Comment
responses are in
magenta.

Falcon Highlands South

Preliminary Drainage Report

PUDSP-22-005

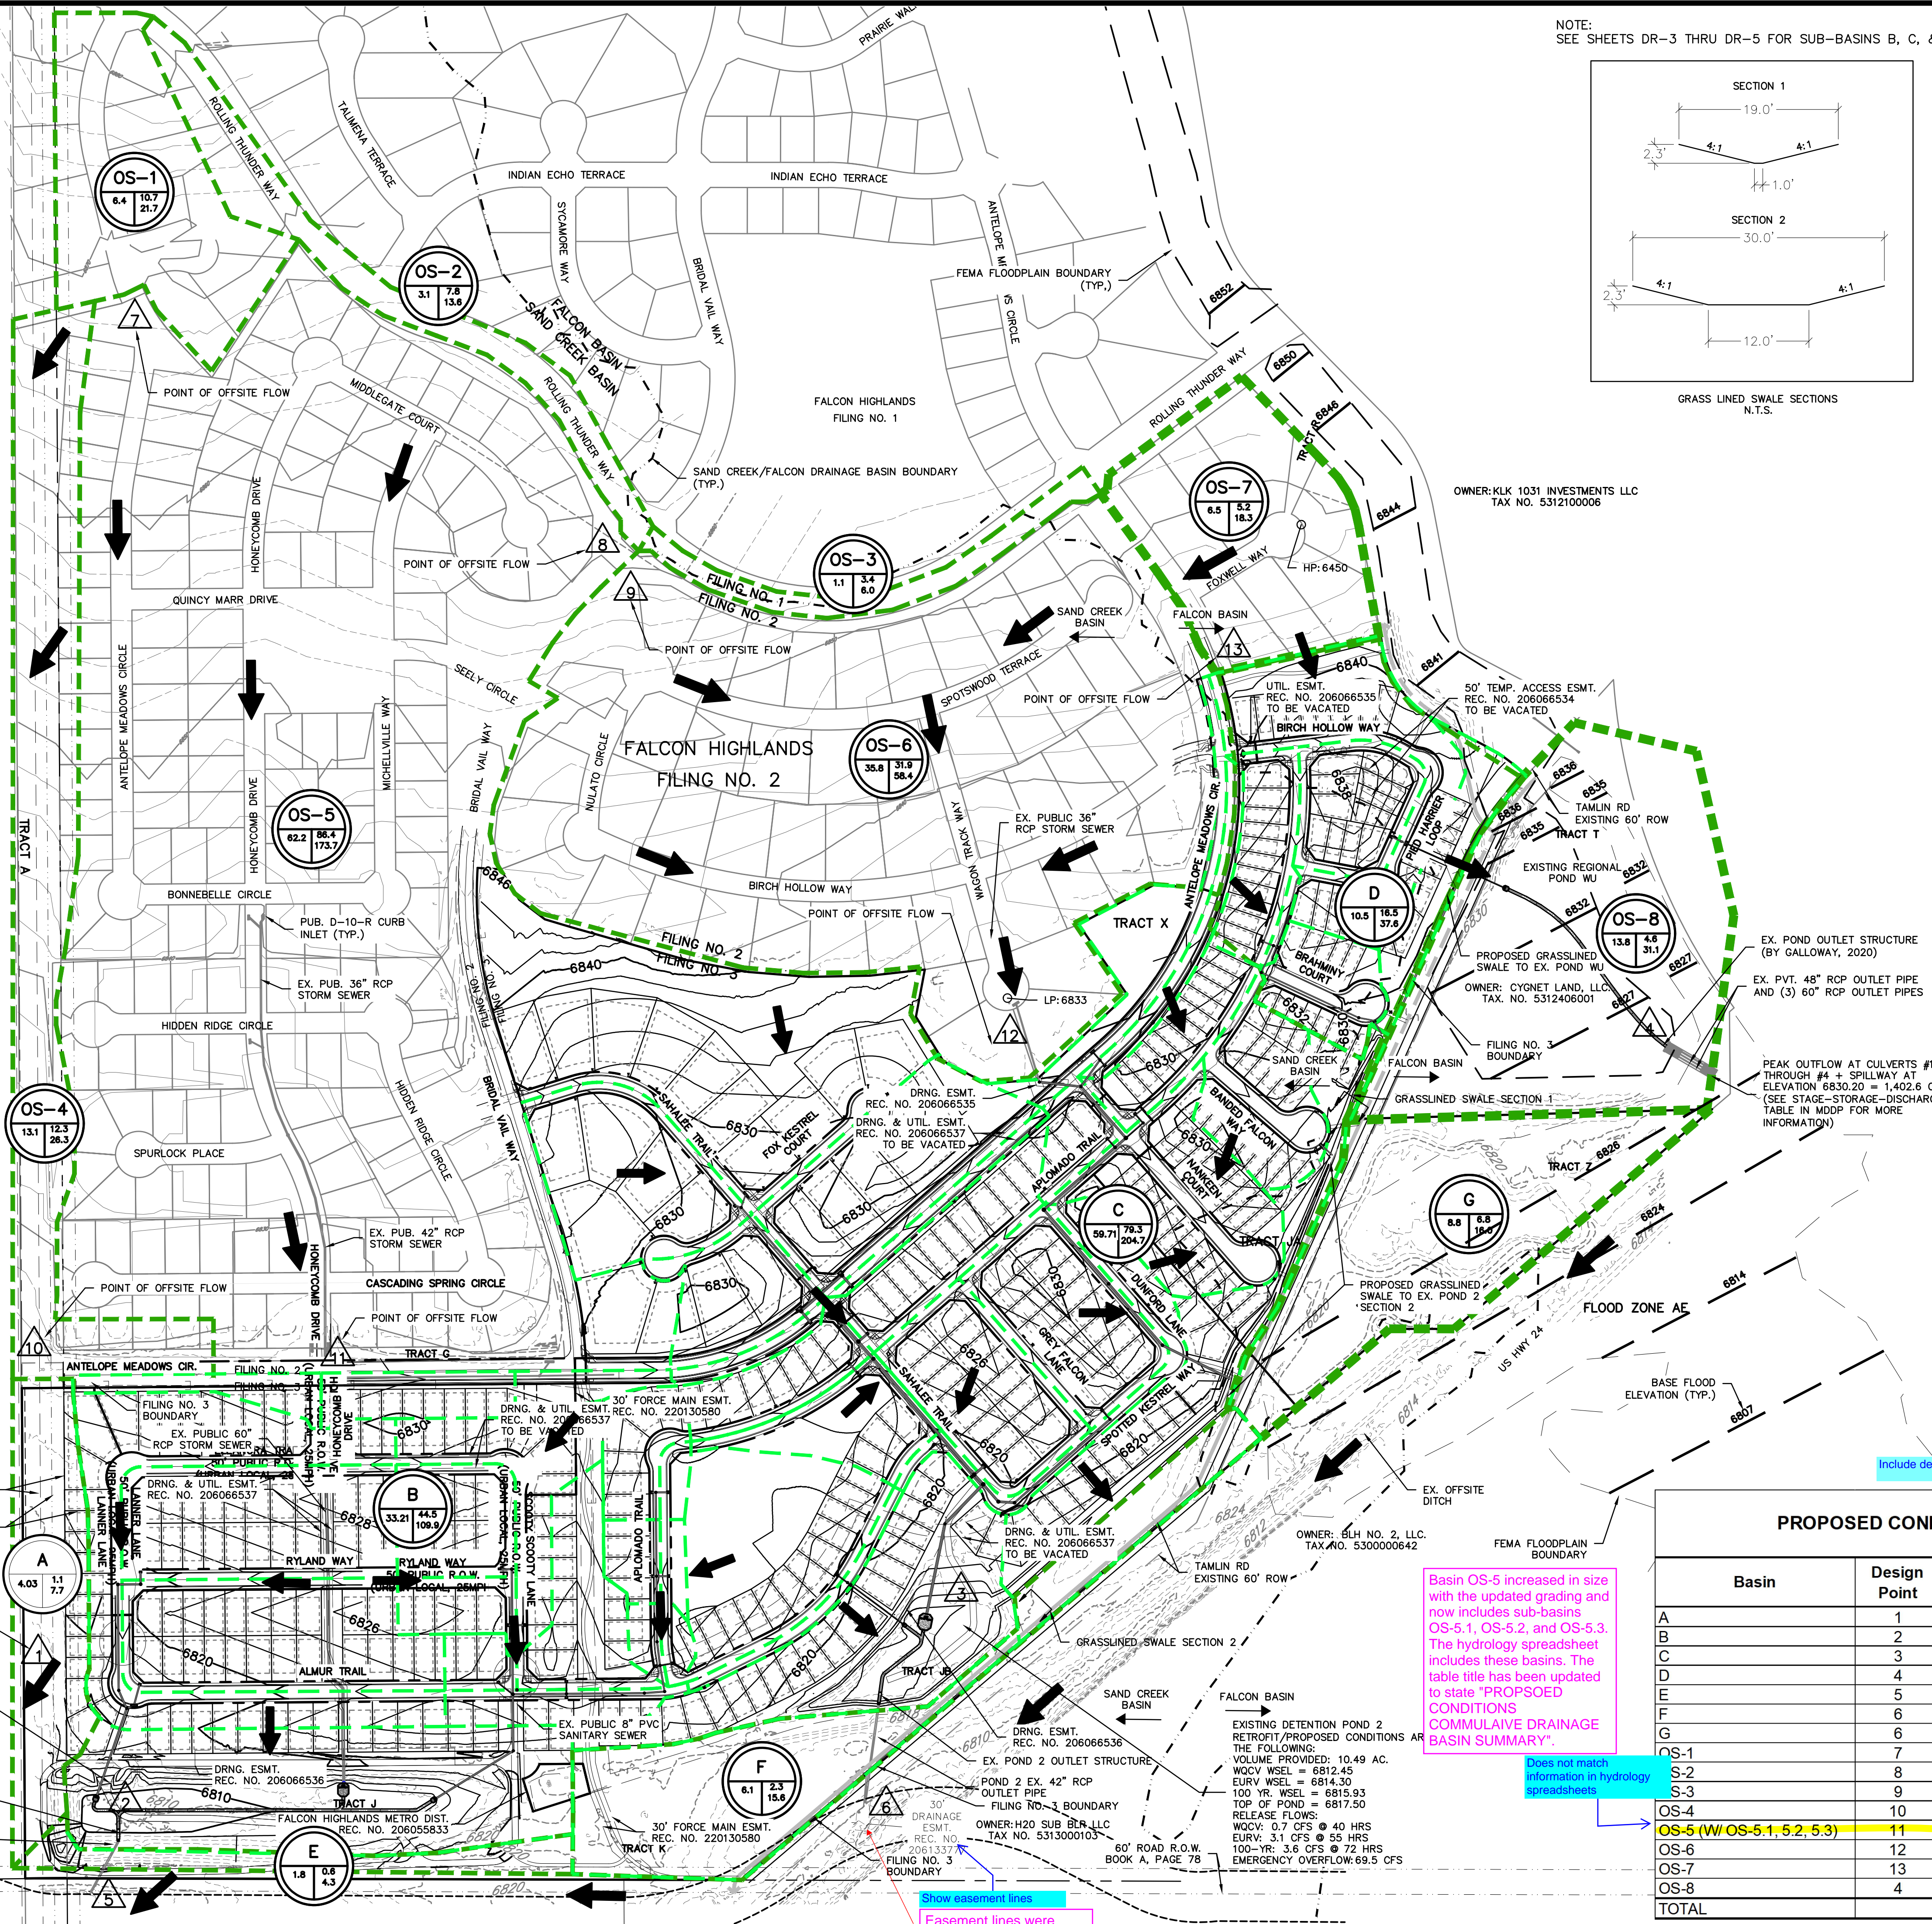
Show easement lines

DR-02

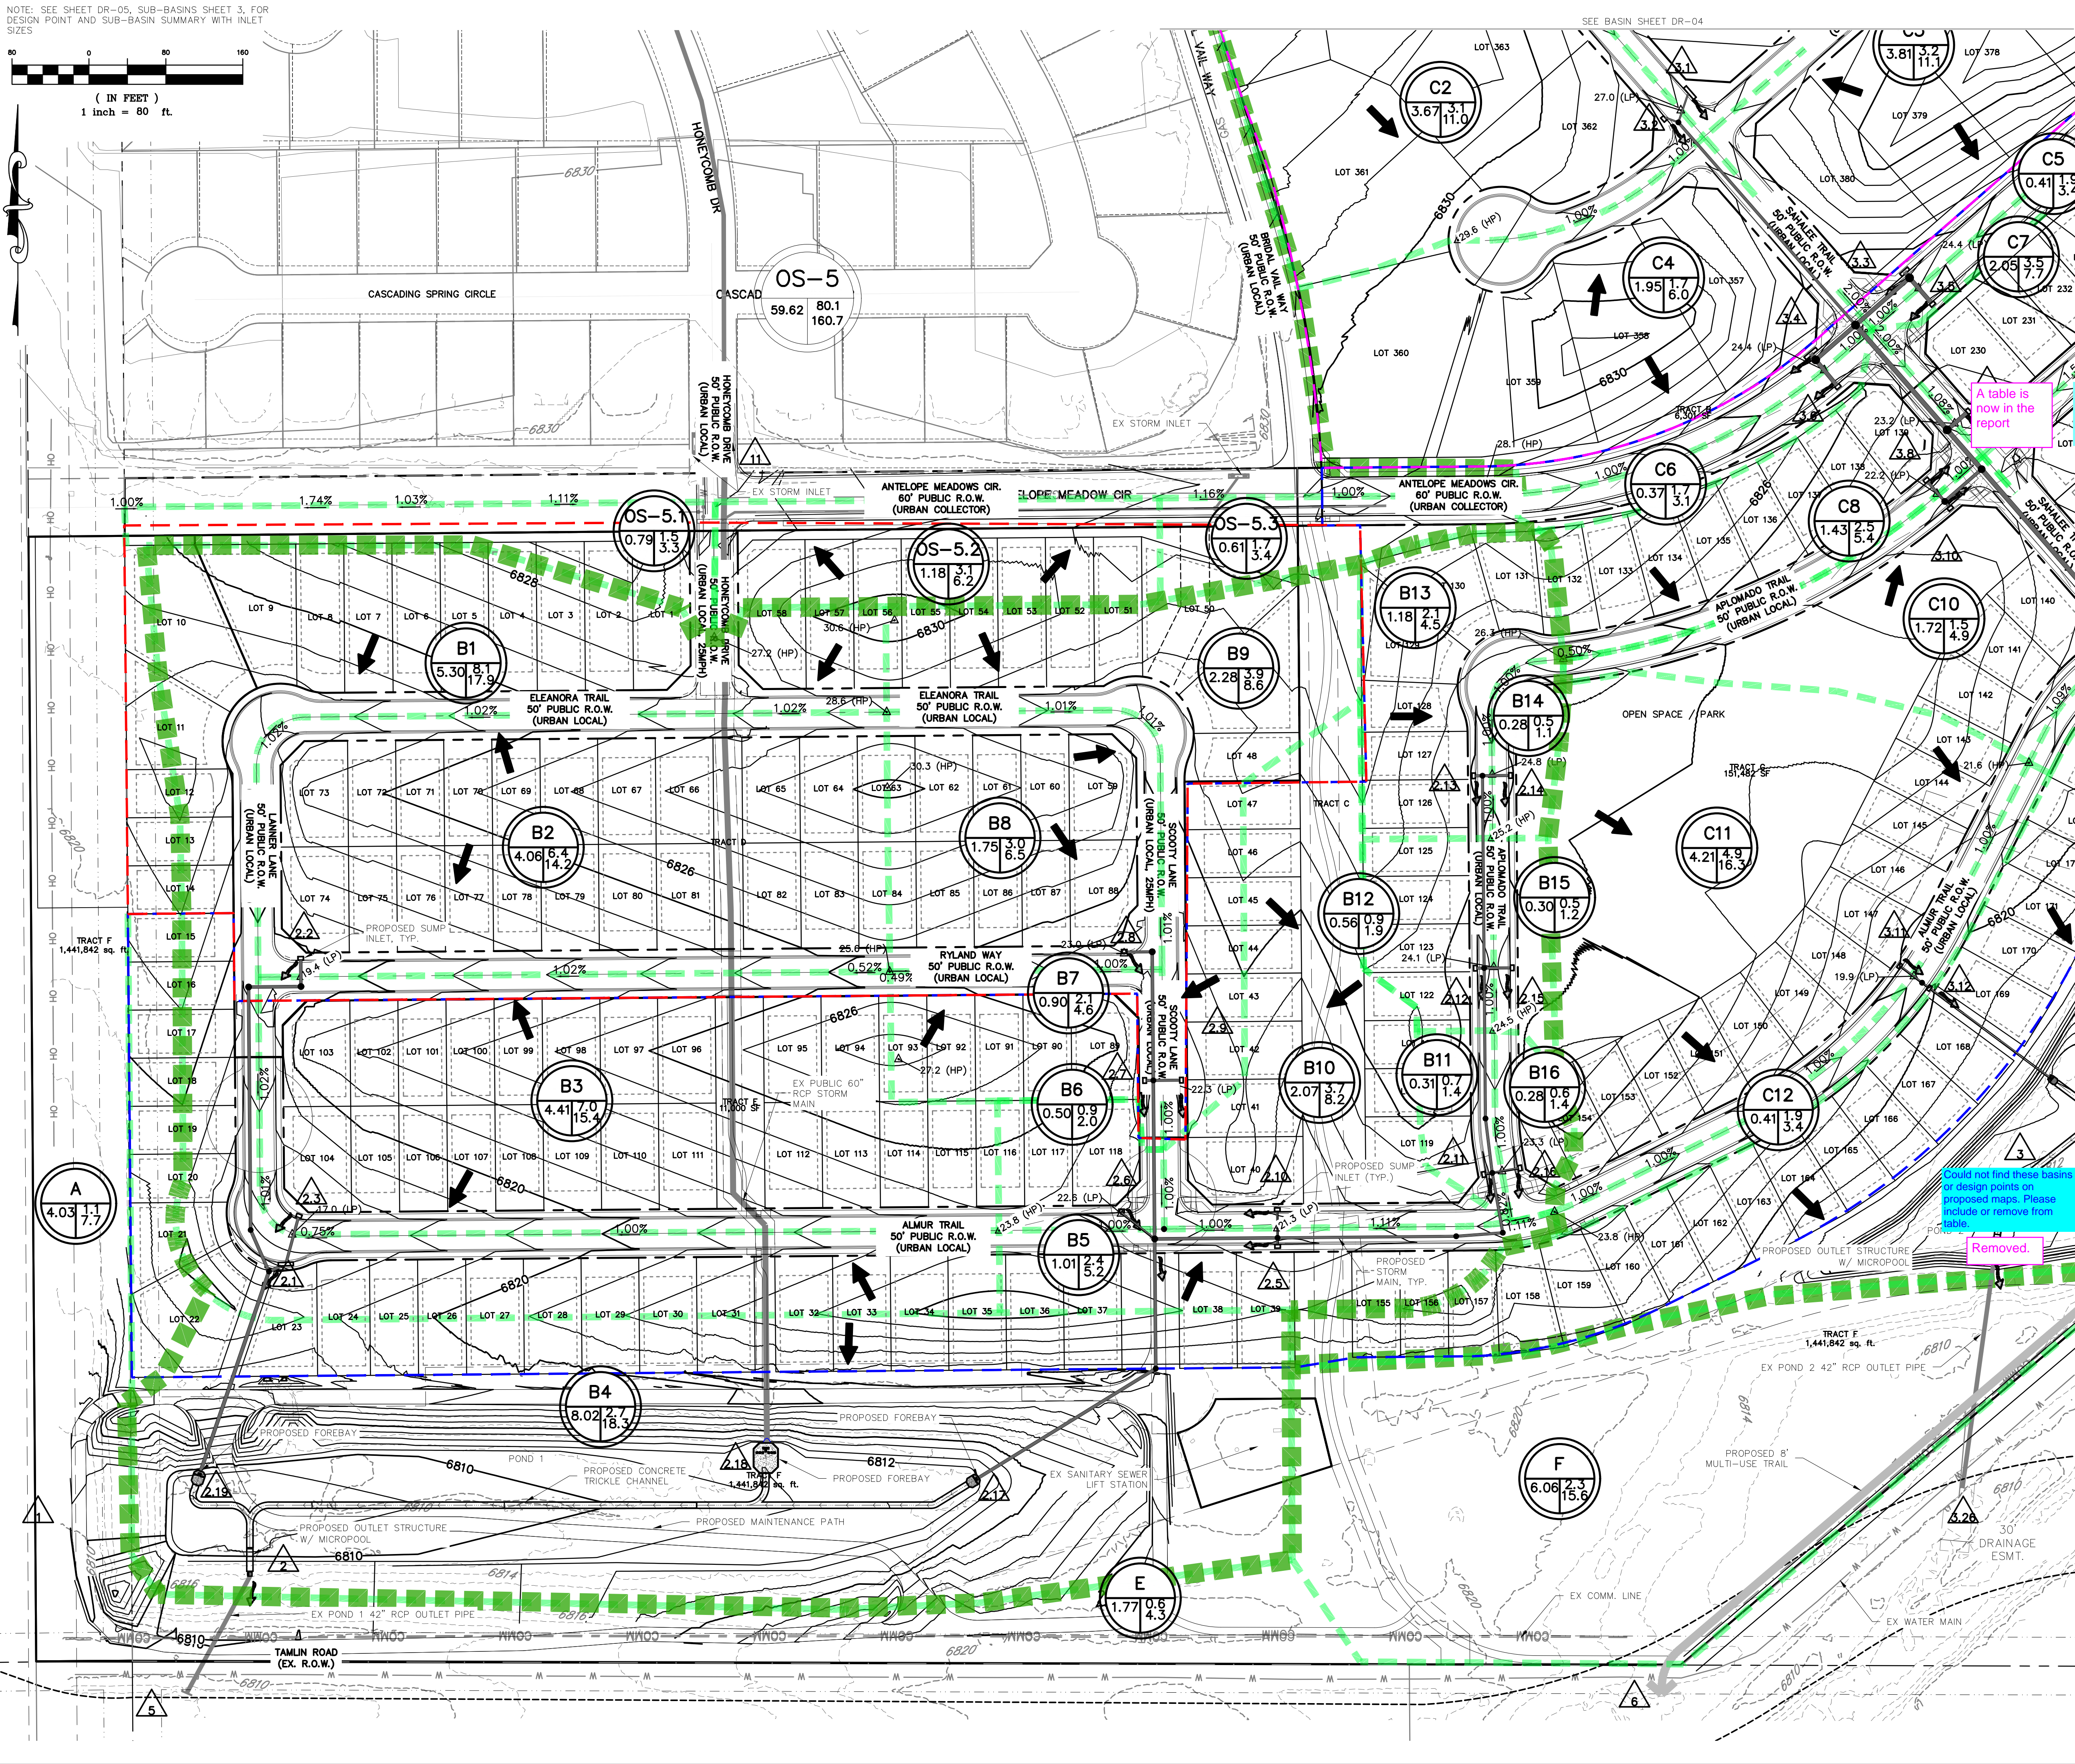
UNRESOLVED: Provide a comparison table in report of historic and proposed flows at each outfall to offsite property

Could not find these basins or design points on proposed maps. Please include or remove from table.

DR-03

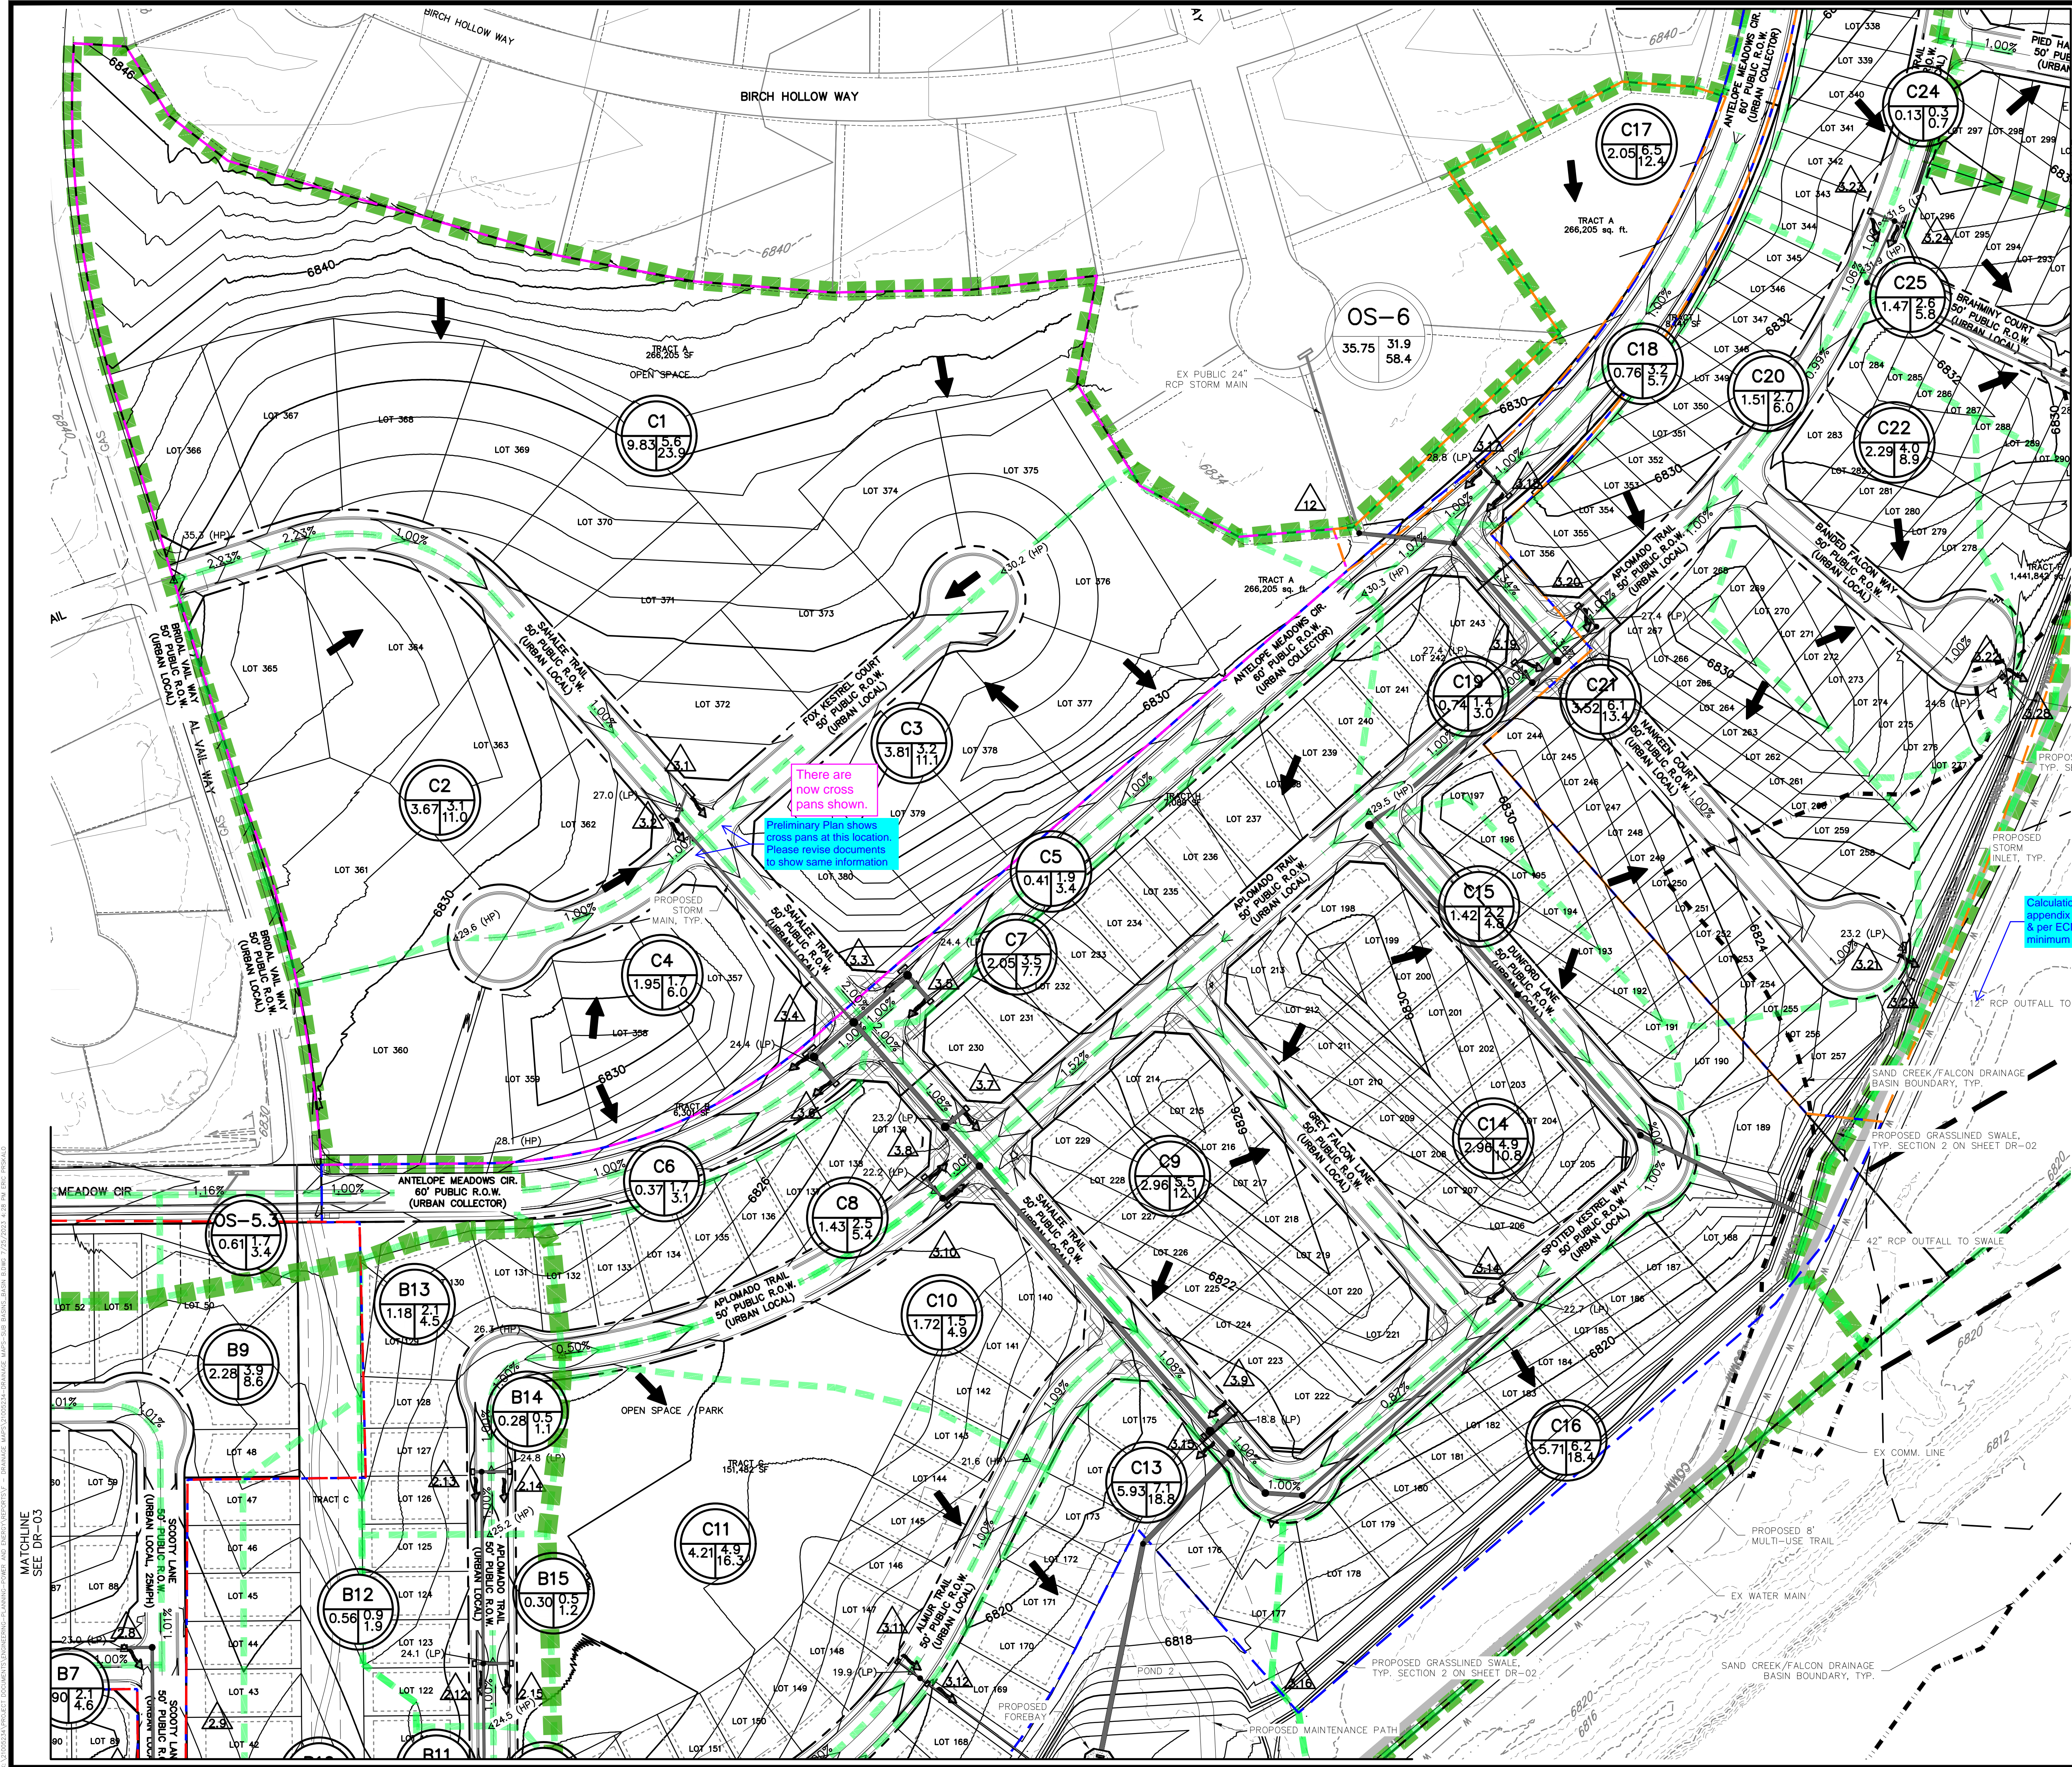
Calculation sheet in RCP appendix shows 18\"/>
